TO: HONORABLE COMMISSION MEMBERS
FROM: Marcia Strange, Director of Community Development
DATE: April 8, 2026
SUBJECT: SITE PLAN REVIEW PSP26-0002 - 802 W MICHIGAN AVE - ROYAL SWINE

Royal Swine BBQ

**ROYAL SWINE BARBECUE
 SITE EXPANSION
 802 W MICHIGAN AVE, MARSHALL, MI 49068
 LAYOUT PLAN**

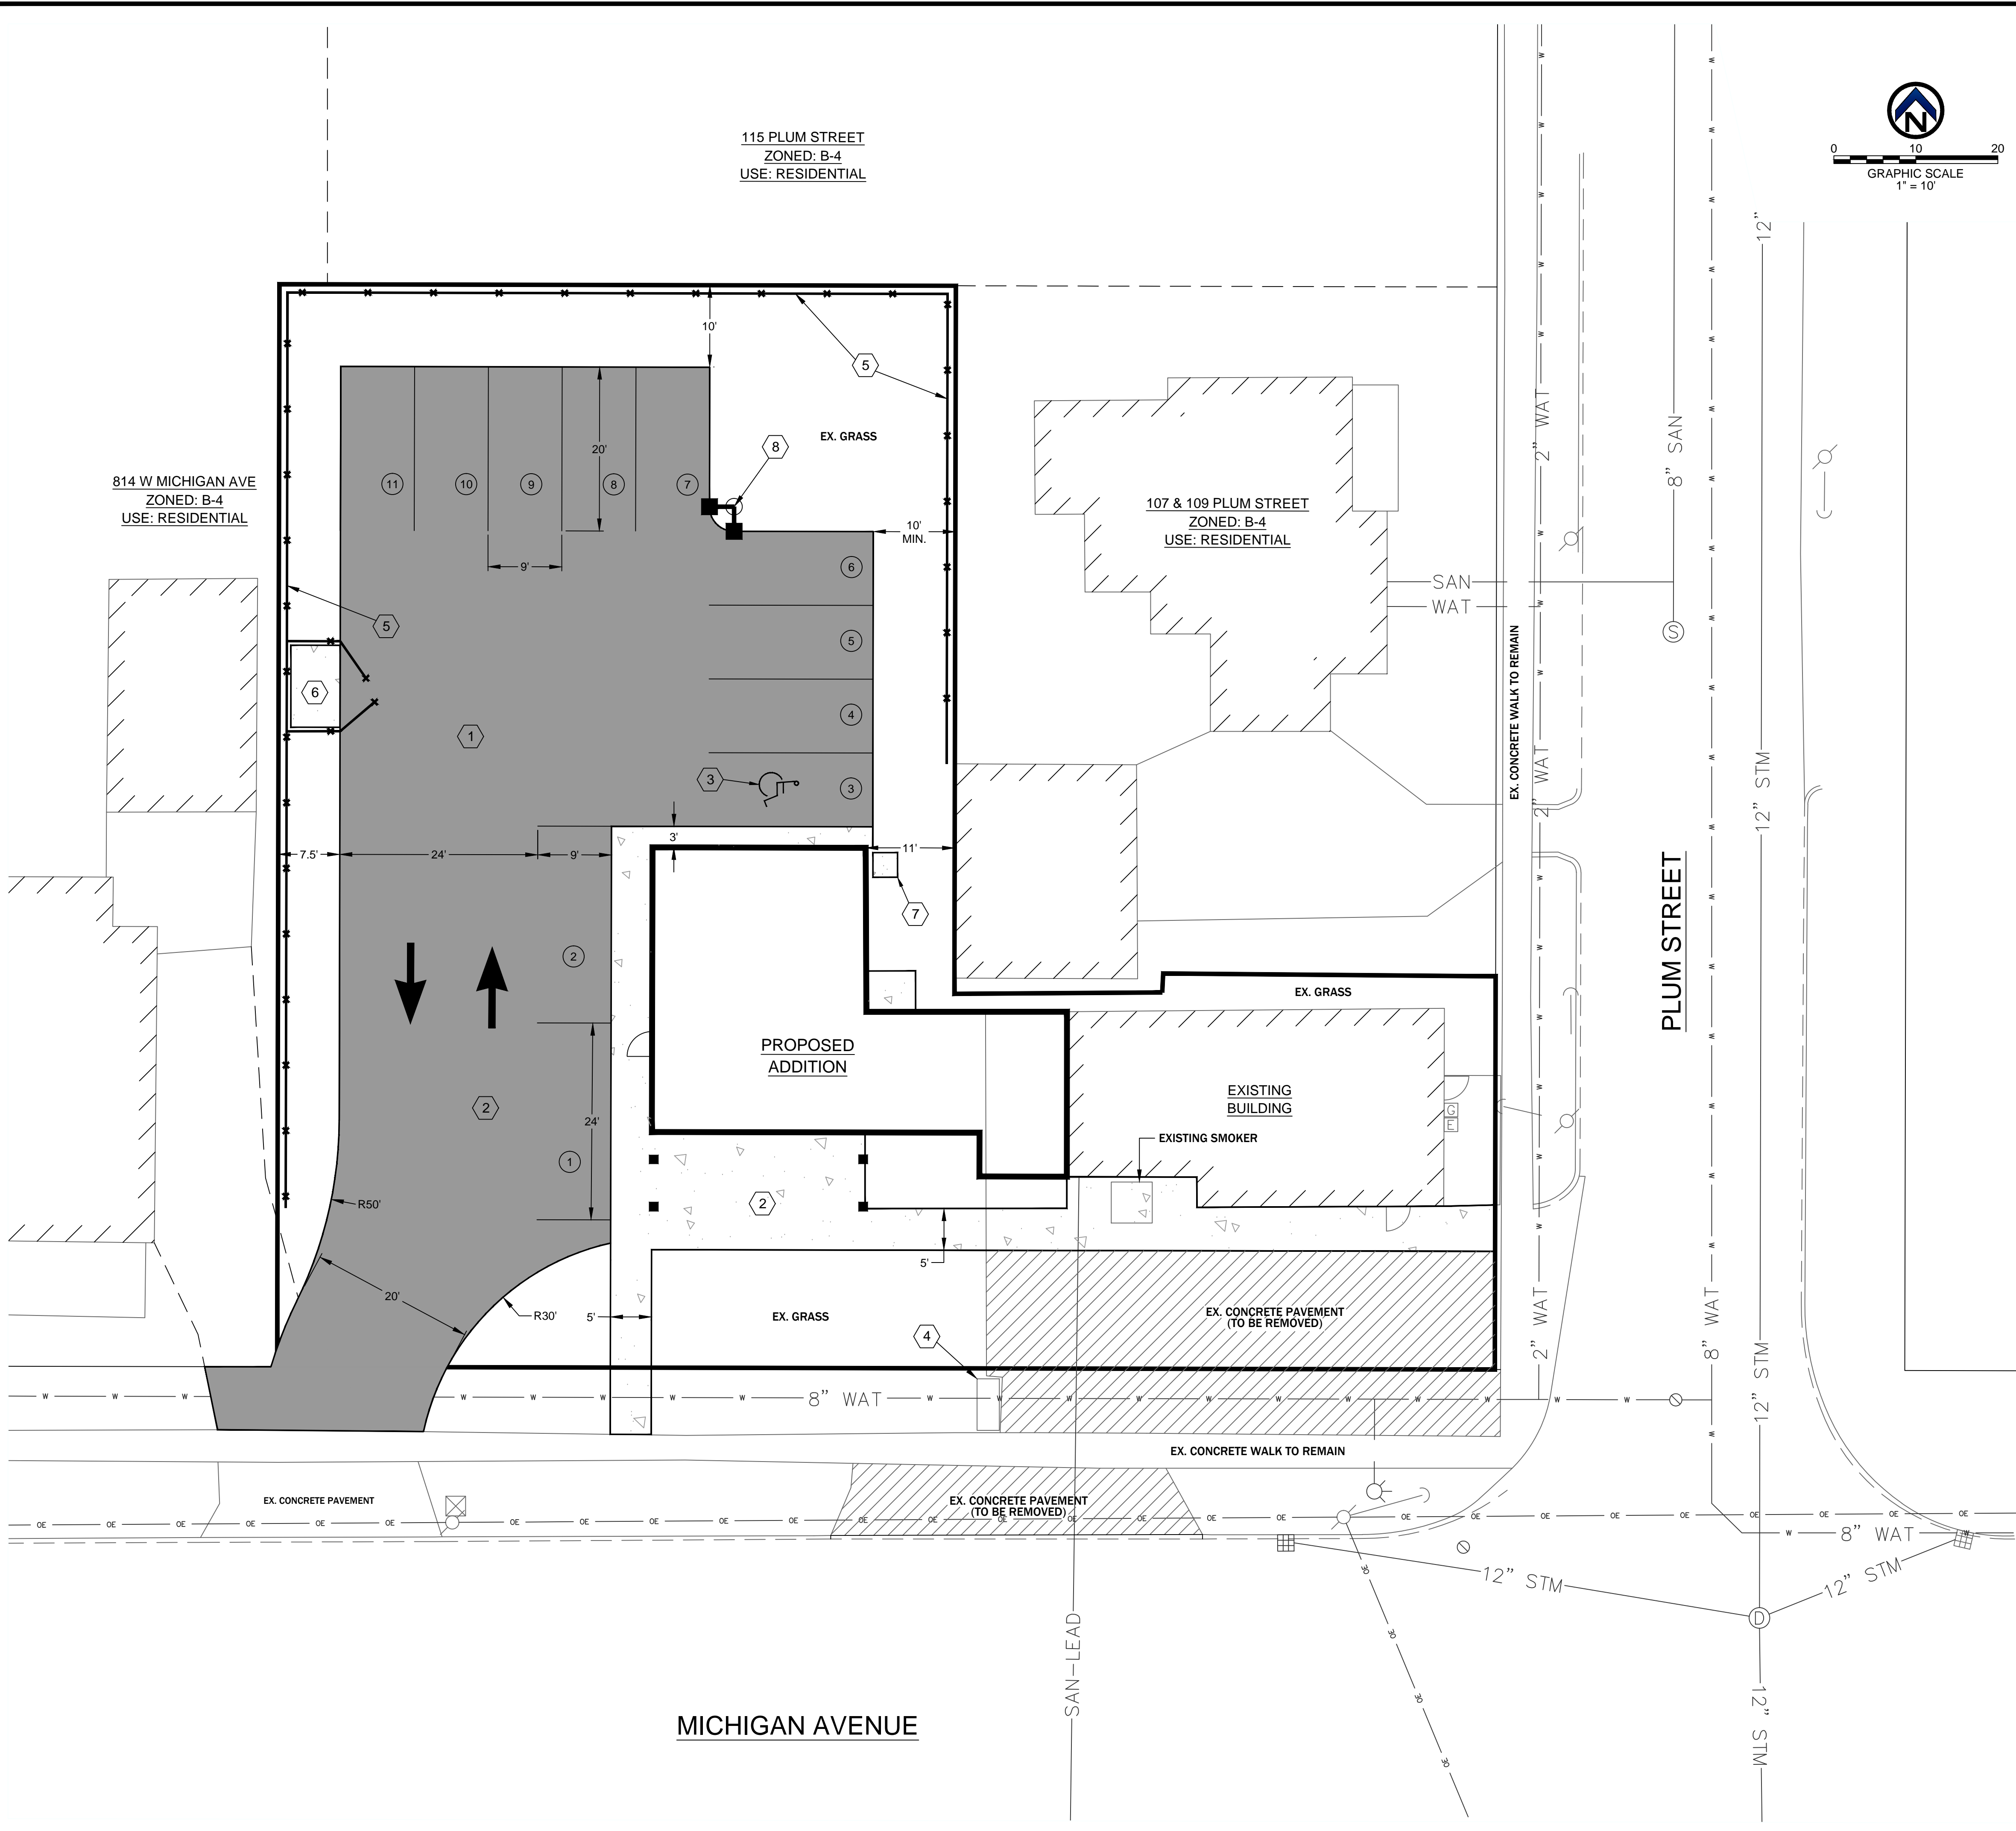
The front yard setback requirement is met. The north setback along the existing is less than required, but the condition is not made worse by the addition. The side yard setbacks are to add up to 25'. The drive is in the required setback.

Parking has been calculated based on the number of seats in the new sit-down portion of the restaurant. We would anticipate 26 seats + 4 staff based on the information provided. There is sufficient space for customers to park and others are able to move by them in the parking lot provided. The existing pick-up condition remains but is not calculated into the parking count. The site is allowed up to two access points based on its size and corner lot condition. Due to the existing

building placement on the very small site, the applicant could not add parking without adding a third drive. It is staff recommendation to allow the parking number as provided.

9. . There are some on-street spots on Plum Street that could accommodate short-term parking for pickup, or staff. Several iterations of the site plan were considered in an attempt to gain parking at the east end of the site and City Staff recommends allowance to "green" the corner of Michigan and Plum in lieu of pushing for additional parking.

10. The existing drive to the west (gravel) will need to connect to the new drive outside the right of way. A paved connection is required for the area. If the adjacent parcel is developed for a commercial use in the future, there is a desire by Royal Swine to coordinate for additional parking through a shared use agreement. That does not affect the current site plan approval, but shared parking would benefit both parcels if the uses are compatible for peak hours.

The plans have been reviewed and approved by the Department of Public Services. The number of drives onto the site has been reduced from three to one. MDOT will need to be notified of the removal of the original Royal Swine drive from Michigan Avenue. A shared-access agreement should be coordinated with the property owner to the west and MDOT and the City should be made aware of the agreement. The owner anticipates the provided parking will manage the pickup counter

The proposed site meets the requirements of the parking ordinance for the new addition. There is concern about accounting for and providing access to the existing walk-in pickup counter on the east end of the building. On-street parking may be utilized between the hours of 6am and 2am, but it is not considered part of the required parking.

Approve site plan 26-0002 for 802 West Michigan Avenue contingent upon:

1. The addition of egress lighting at the north exit door.
2. Adjust the access to the adjacent parcel to be outside of the right-of-way and provide a shared access agreement for that drive.

ROYAL SWINE BARBECUE
SITE EXPANSION
802 W MICHIGAN AVE, MARSHALL, MI 49068
LANDSCAPE PLAN

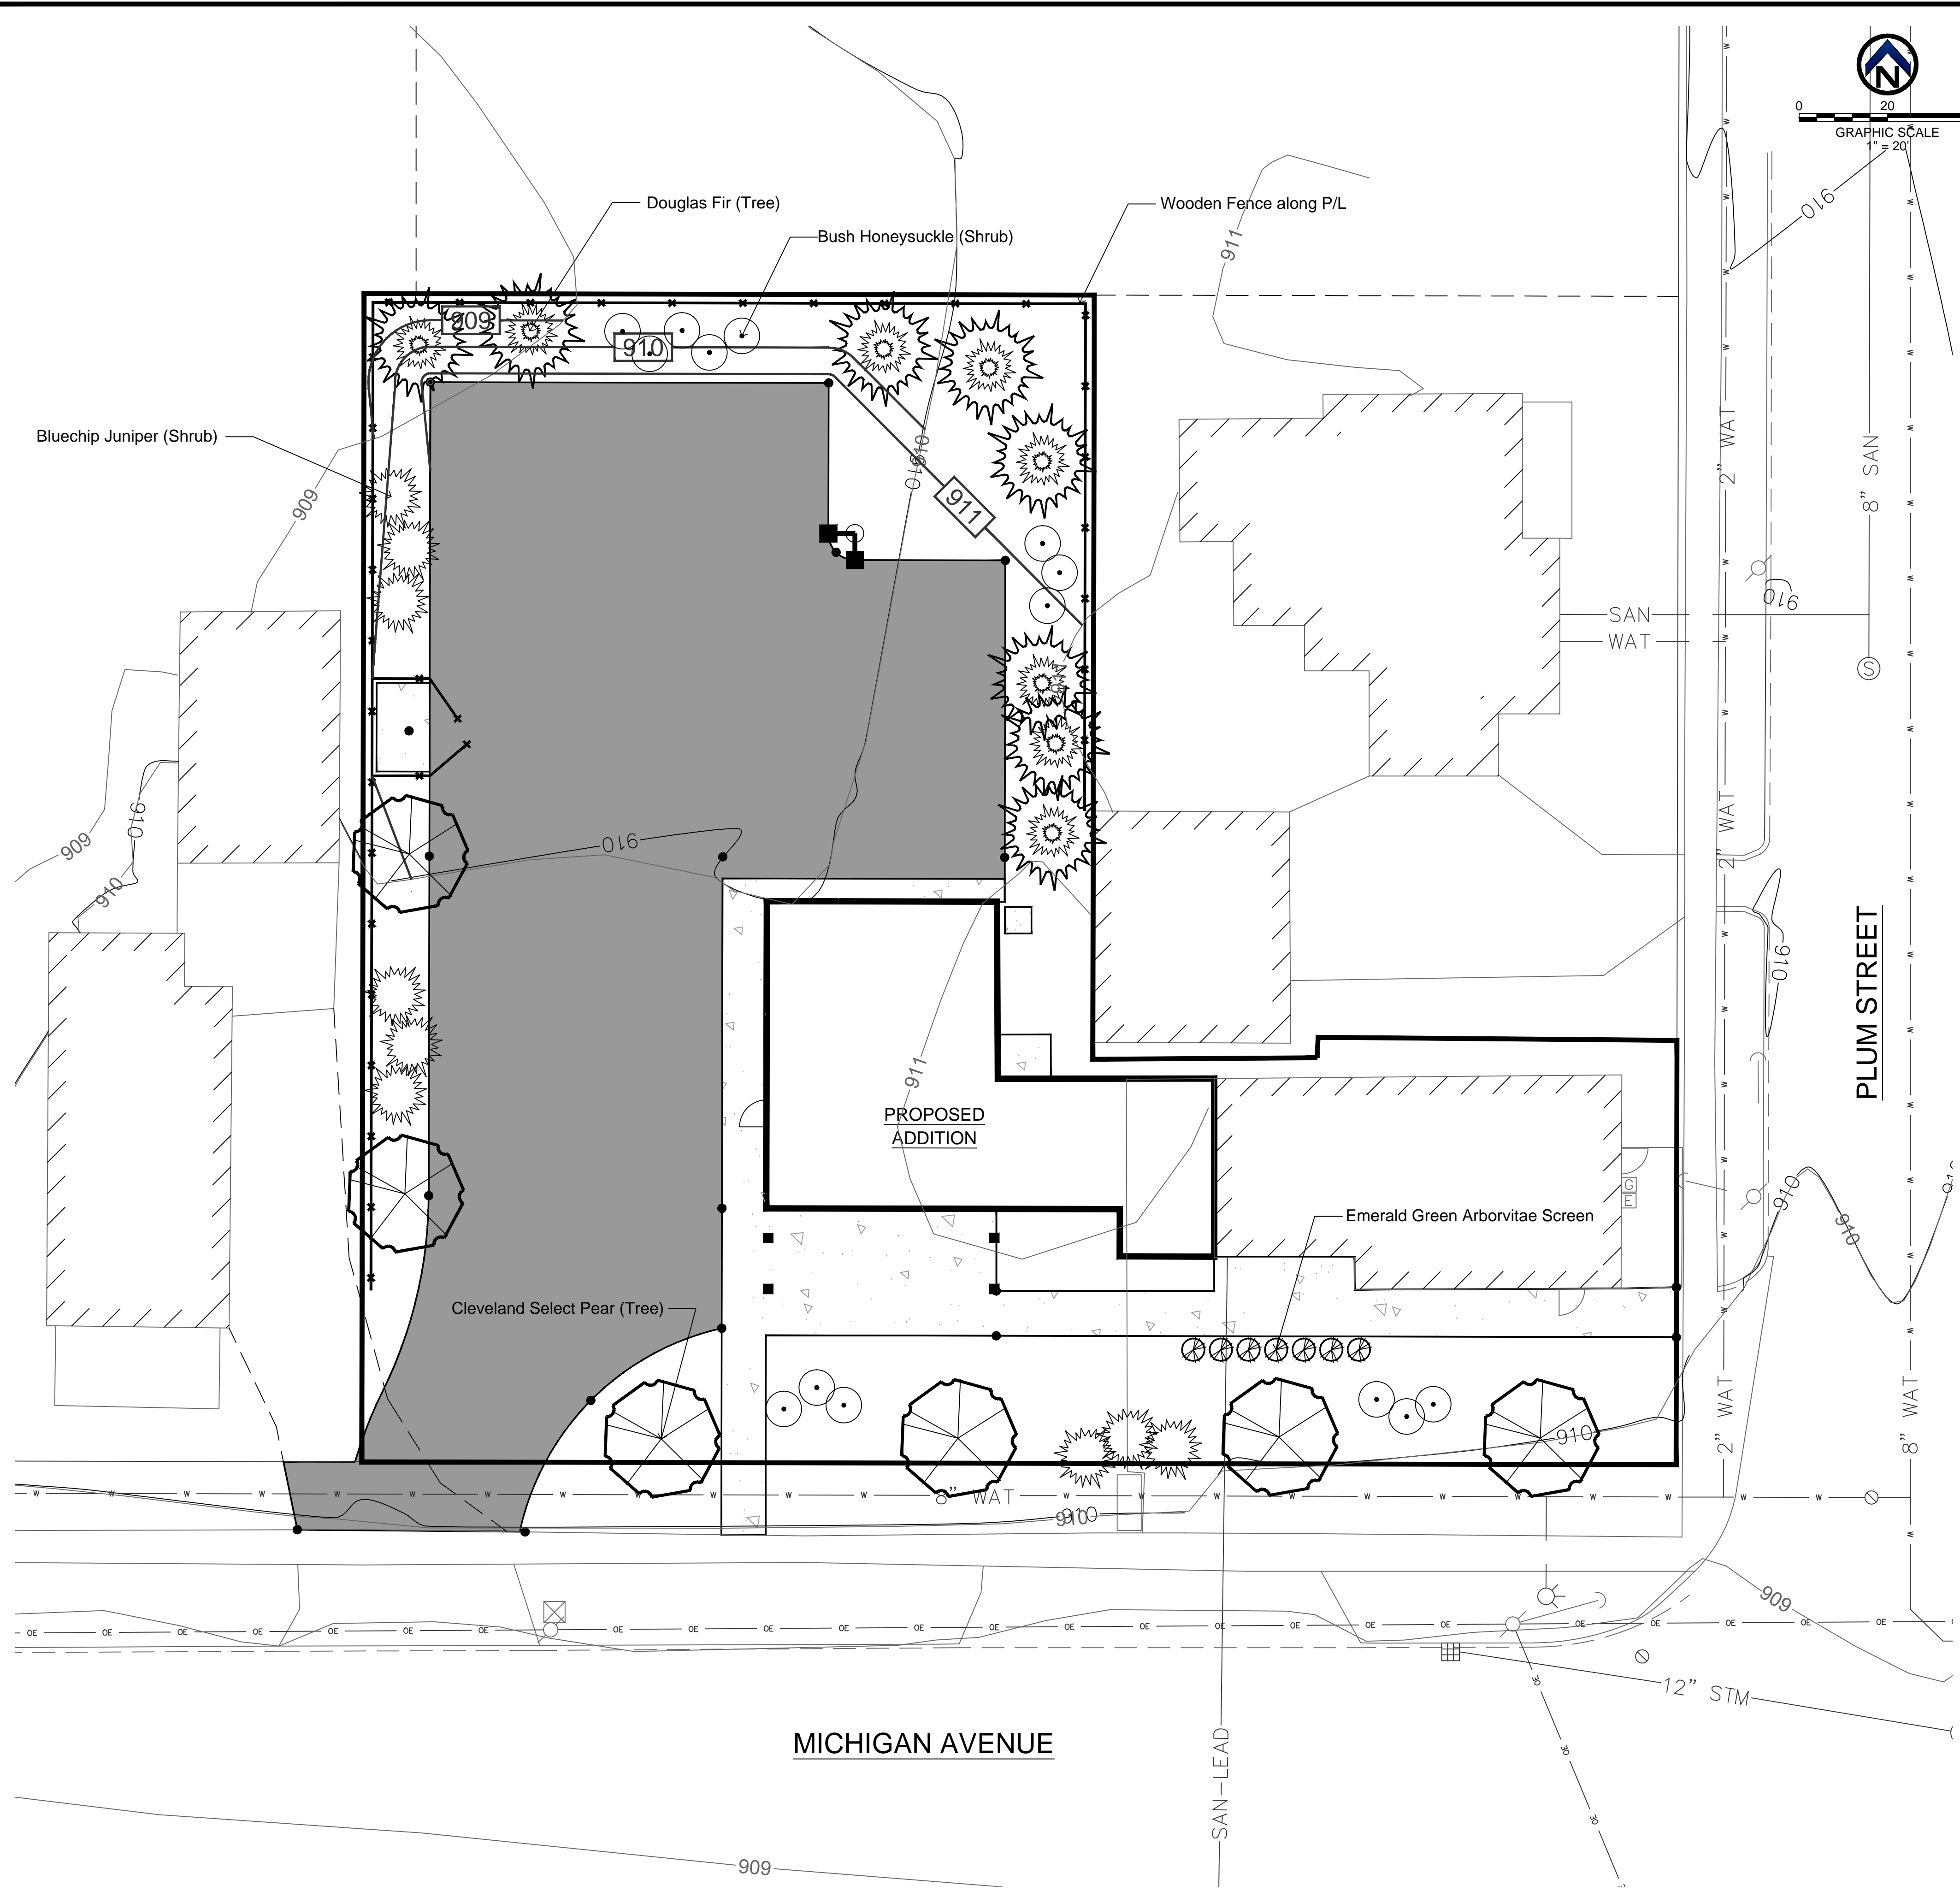
The landscape plan does not have to be stamped by a Landscape Architect due to the size of the parcels (<1 acre). A requirement for at least one deciduous tree and four shrubs per 40 lineal feet of street frontage is required and has been provided. Parking lot landscaping is also provided. Screening in the form of a fence has been provided from neighboring residential uses. The smoker has been considered "mechanical equipment" and, because of its location on the front of the building, additional screening has been provided from the ROW. The removal of old paving and replacement with additional landscaping along Michigan Ave is well received.

3. The neighbor's existing garage is built on the property line. It was recommended not to add a fence behind the garage so that the garage owner can maintain their property as needed. This adjustment has been made.

6' tall fencing will screen the site from the residentially used properties to the west and north. A row of arborvitae will be planted to screen the mechanical equipment at the front of the building.
